Subject: American River College – Davies Hall
Lift Slab Construction/Structural Review
4700 College Oak Drive
Sacramento, CA 95841

RE: DSA A#26784 Davies Hall, American River College

Fig. 1: Plan View of Lifting Collar, Detail 3/L8

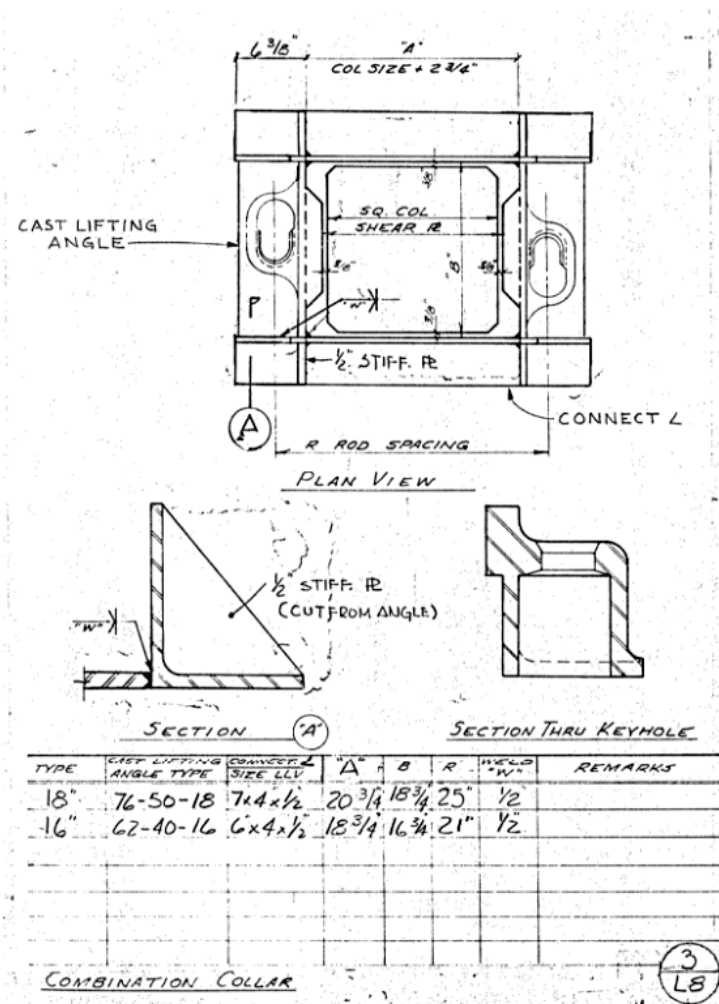
configuration of the building, the foundations, the design of the lateral force resisting system and the attachment of the exterior precast elements, etc. there are then the L sheets that range from L1 to L8. These drawings generally depict the post-tensioned design for the floor and roof slabs, the design of pre-cast reinforced concrete columns as well as the details for the lifting collars and the interface between the lifting collars that are cast into the slabs and the interface with the column. Below are the details that we believe are the most indicative of lift-slab construction:

Based upon our observations in the field and on the drawings, it is our opinion that the subject building is of lift-slab construction. The fireproofed collar observed in the field suggests that there is a steel component adjoining the slabs to the columns that is vulnerable to fire. This would not be the case with conventional reinforced concrete flat-slab construction. Observing the details both in the "S" sheets and the "L" sheets of drawings marked "as built," lift slab construction was used unless, for some unlikely reason, these drawings are not correct.

1. Verify the existing construction of the lifting collar and column interface with non-destructive testing and removal of some of the fireproofing. It will be very important to understand this connection to understand the fragility of the building with respect to lateral forces.
2. Perform a lateral analysis of the existing building structure using modeling techniques that will capture the flat-slab and column frame action and the ability of the column slab connections to sustain these actions. Looking at the buildings lateral force resisting system, we do not believe the current system is very stiff and there may be significant interaction with the slabs and columns.
